ECN/PCN No.: 4499

CONTINUOUS VOLTAGE SMD CRYSTAL OSCILLATOR

ASADV

Mechanical Dimensions

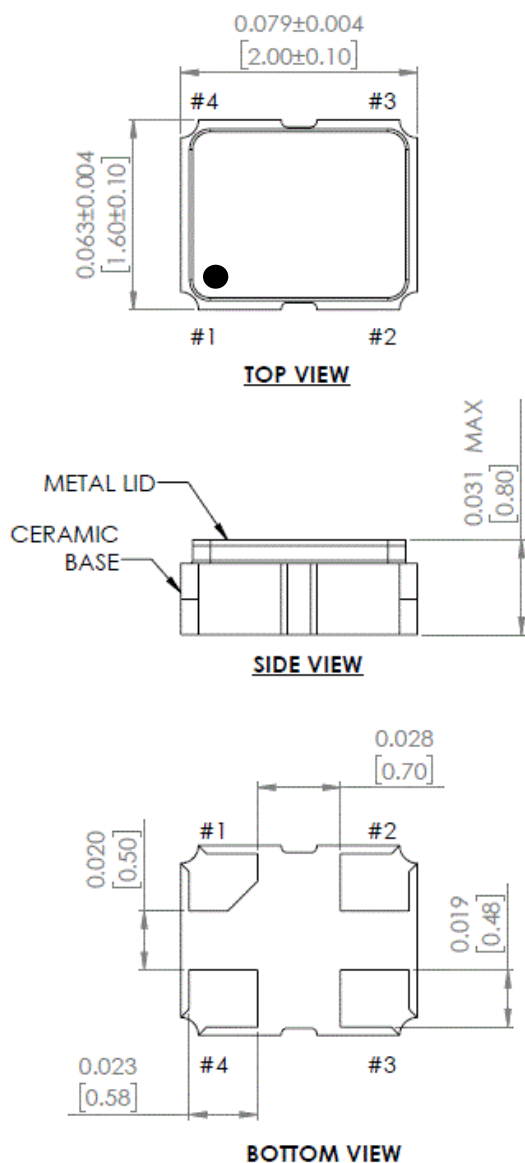
For Manufacturer			
Product Description: ASADV	Abrakon Part Number / Part Series: CONTINUOUS VOLTAGE SMD CRYSTAL OSCILLATOR	<input type="checkbox"/> Documentation only <input checked="" type="checkbox"/> ECN <input type="checkbox"/> EOL	<input checked="" type="checkbox"/> Series <input type="checkbox"/> Part Number
Affected Revision: F	New Revision: G	Application:	<input type="checkbox"/> Safety <input checked="" type="checkbox"/> Non-Safety
Prior to Change: Package (top view), marking scheme: pin 1 dot not included  <p style="text-align: center;">TOP VIEW</p>			
After Change: Package (top view), marking scheme: pin 1 dot included  <p style="text-align: center;">TOP VIEW</p>			
Cause/Reason for Change: To facilitate customers with part orientation.			
Change Plan			
Effective Date: 10/27/2022	Additional Remarks: N/A		
Change Declaration: The addition of the pin 1 dot laser-marking does not impact the electrical nor mechanical performance of the device.
